RE: Project Update
Baxter Road Temporary Stabilization Application
Town of Nantucket
Nantucket, Massachusetts
MMI #2967-11-4

1. Revised project plans (dated November 5, 2013) are attached to this letter. A record set will be brought to the November 6, 2013 hearing. Revisions reflect minor changes as follows:

BAXTER ROAD TEMPORARY STABILIZATION NOI SUBMISSION

October 25, 2013
REVISED: NOVEMBER 5, 2013

TYPICAL CROSS SECTION - TEMPORARY SLOPE STABILIZATION

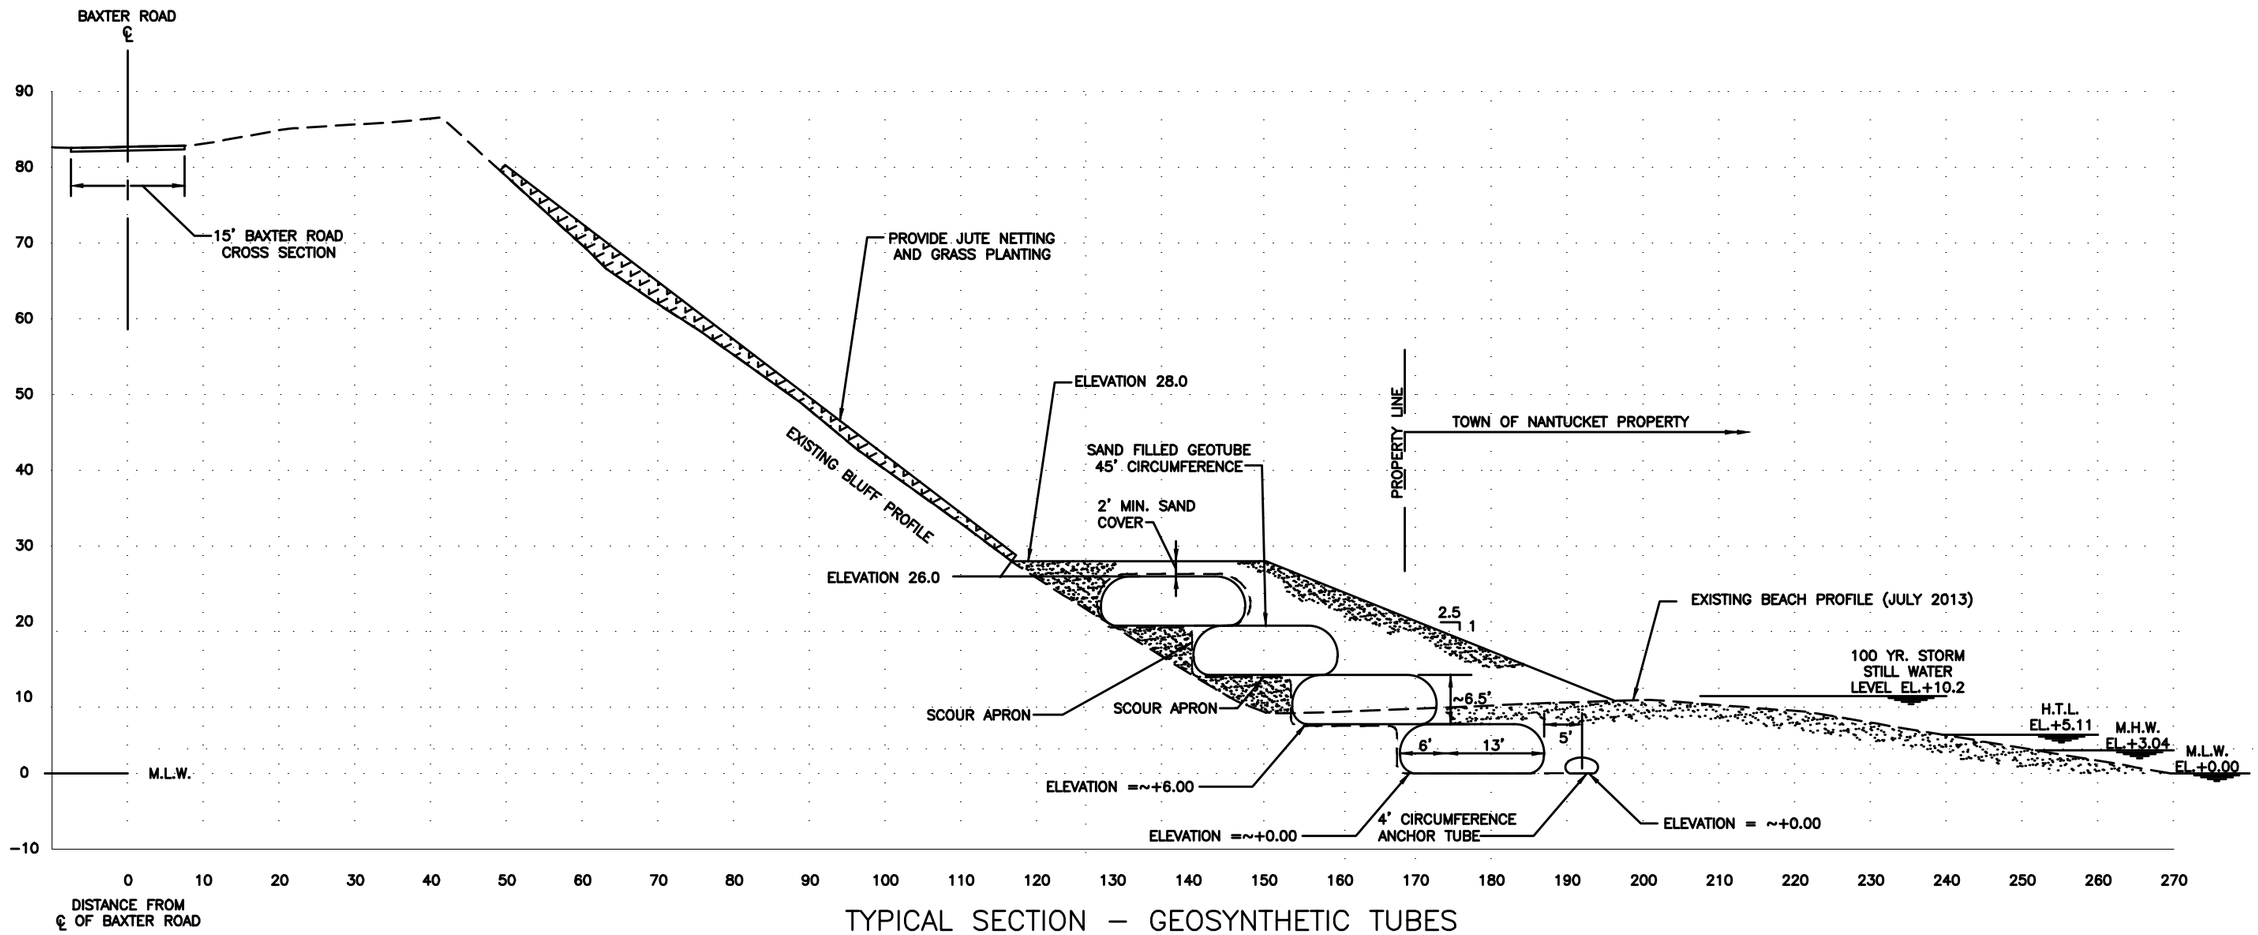
a. The scour anchor at the upper project limit is eliminated. Current plans call for the scour apron to be wrapped around the upper tube. This was done to eliminate the need to cut into the bank.
    b. The Flanking Detail presented at the hearing of October 30, 2013 is included in the plan set.
    c. The construction staging area detail presented at the hearing of October 30, 2013 is included in the plan set.
